SERVICE BULLETIN

MD-80/90 & B717 SERIES

PASSENGER ADDRESS SERVICE INTERPHONE CALL SYSTEM (PASICS),
ATTENDANT HANDSET ASSEMBLY P/N 686-1000-002, MODIFICATION TO
PRECLUDE INTERMITTENT RESETTING.

686-1000-23-5

**Figure 1. A2 Circuit Card
Solder Side – Location of C8**

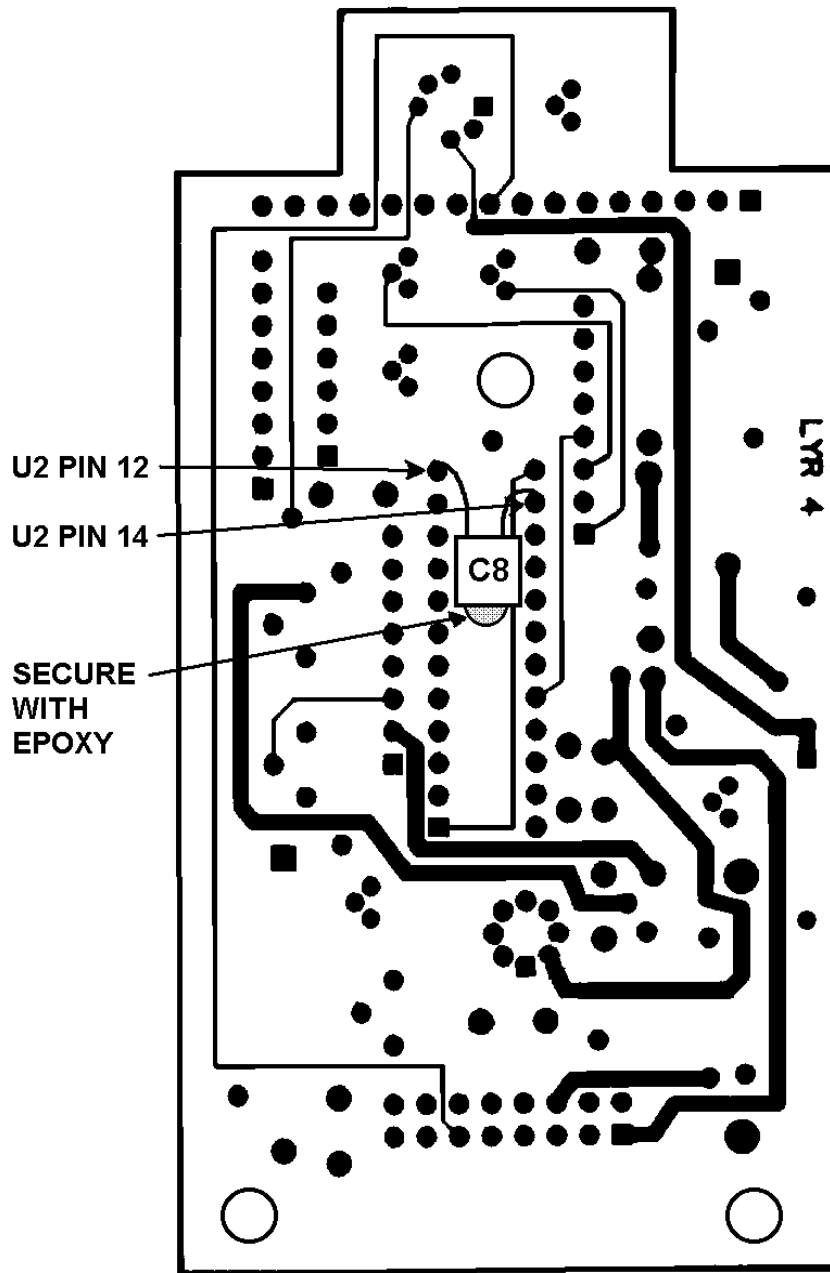
- (1) On the A2 card, locate and remove the defective U2 component. Install new replacement component P/N M235A909-1.
- (2) Install new capacitor C8, P/N M39014/01-1219 (100pf, 200V), on solder side of card, to U2 pins 12 & 14, as shown in Figure 1 of this bulletin.
- (3) Using a small quantity of clear fast drying epoxy, secure C8 to card surface, as shown in Figure 1 of this bulletin. Allow epoxy to dry before proceeding.
- (4) Using an acid brush and isopropyl alcohol, clean newly soldered areas. Ensure cleaned area is dry, then apply conformal coating (Humi Seal 1B31) on all reworked areas.

D. Identification:

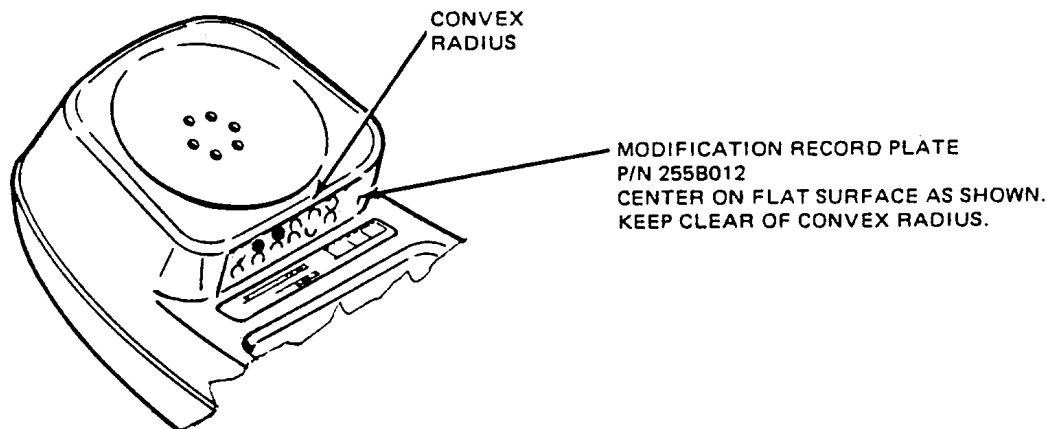
- (1) At the Modification record Plate, obliterate the circled numeral ⑤, using black epoxy ink. If unit does not have a modification record plate, install one as follows:
 - (a) Using a clean, soft cloth moistened with isopropyl alcohol, clean side of deck assembly where modification record plate will be installed, as shown in sketch below.
 - (b) Strip protective paper from adhesive backing of modification record plate P/N 255B012 and install on deck above ID plate as shown below. Press with fingers to ensure maximum adhesion.

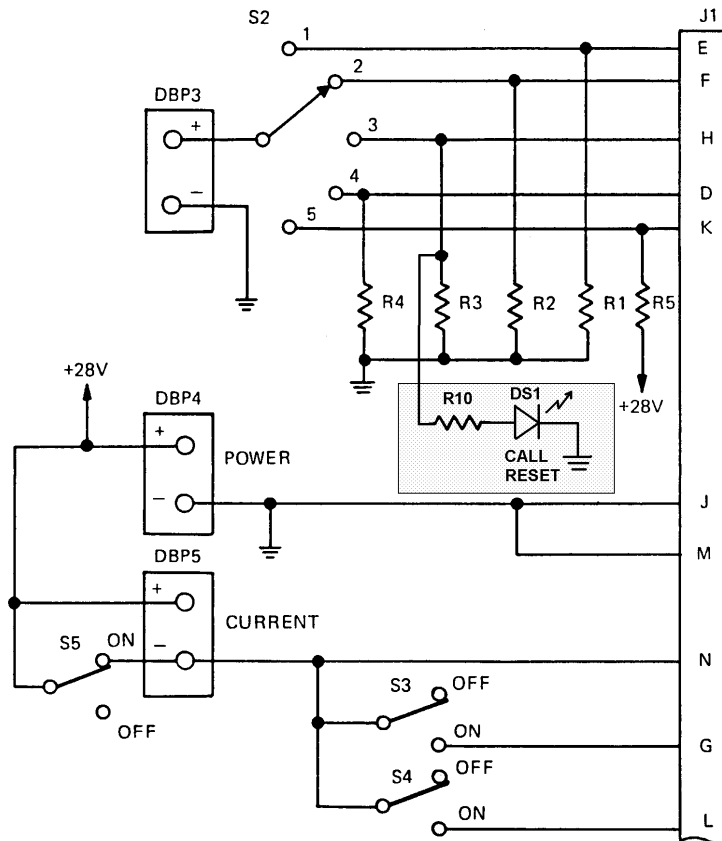
Modification to the tester includes the addition of one LED indicator and one resistor. Depicted below is a partial schematic of the tester, with the added circuitry shown in the shaded area. A parts list for the new items is also provided below.
